207-209 Fore St.

2 Unit Condo.

Revised Traffic Analysis Memo

Subject: **Response to Traffic Comments**
Old Port Hospitality, LLC – Phase 2
Fore Street, Portland

SCALE: NTS
 DATE: 07/22/2010
 SHEET: Fig. 2

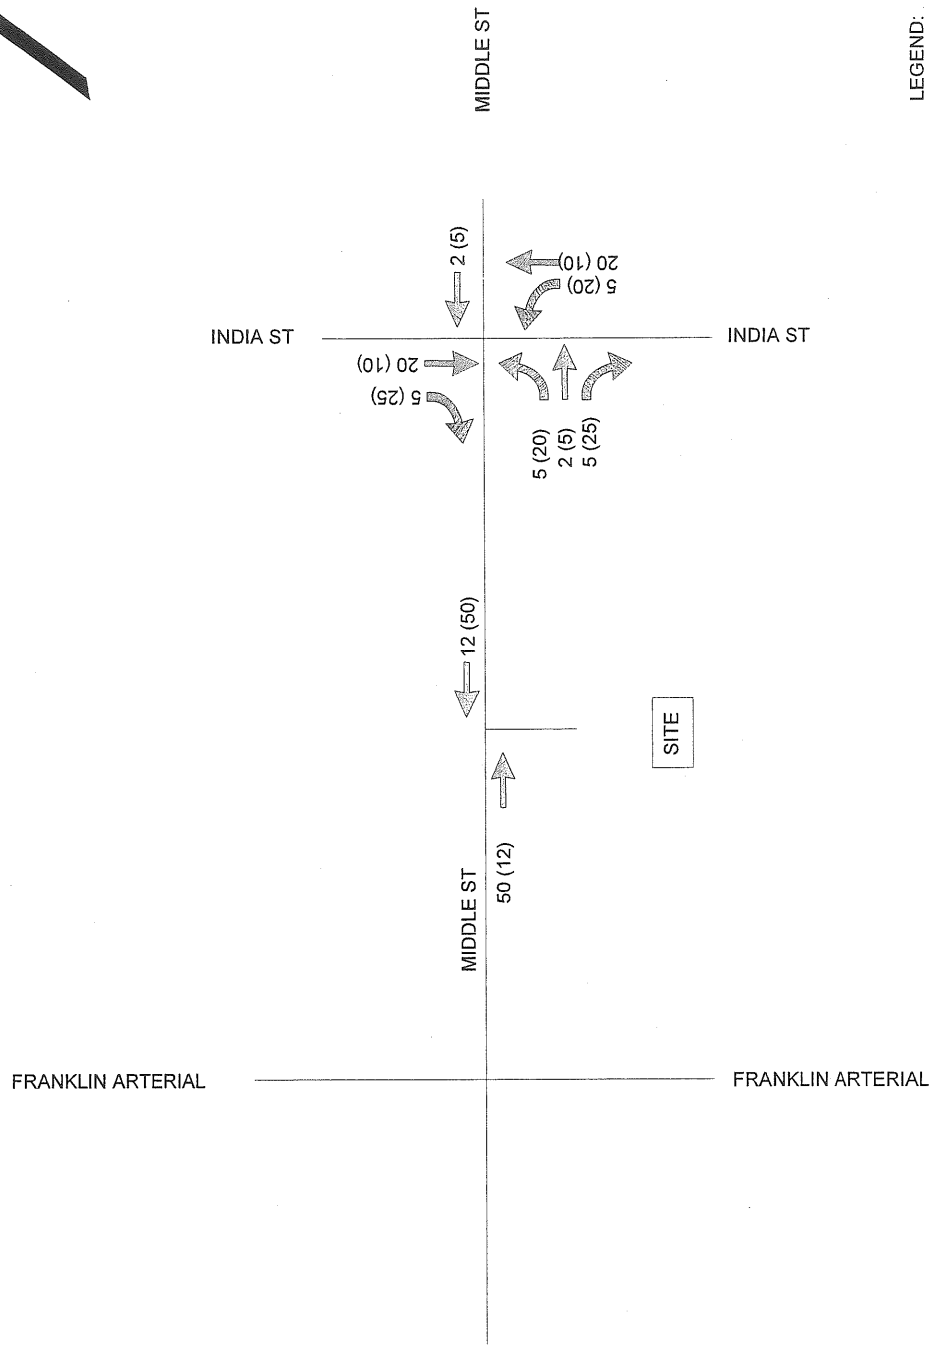
analysis. The build condition includes the four townhouses in Phase 2 and the 70,000 s.f. of general office space in Phase 3. Table 3, shows the operations analysis at the proposed site entrance on Middle Street. The site entrance on Middle Street has been revised to be located approximately 240 ft. from India Street.

**AM & PM SITE GENERATED TRIPS
 PHASE 2 & PHASE 3 INCLUDED**

SHEET: Fig. 3

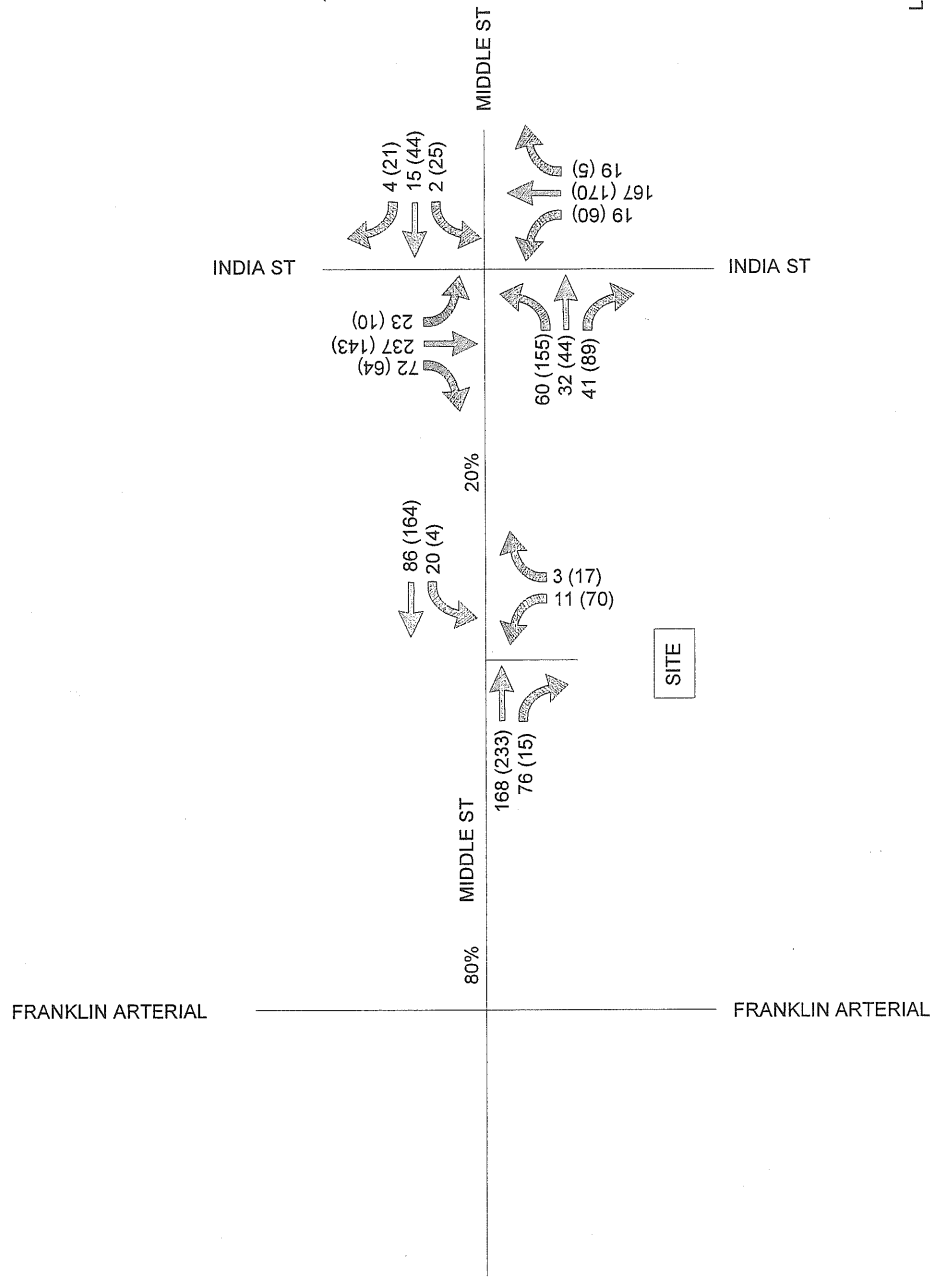
Response: We have included other development trips for the Riverwalk and Bayview projects. The other development trips are shown in Figure 3 enclosed at the end of this report.

OTHER DEVELOPMENT TRIPS INCLUDE: BAYVIEW AND RIVERWALK PROJECTS.
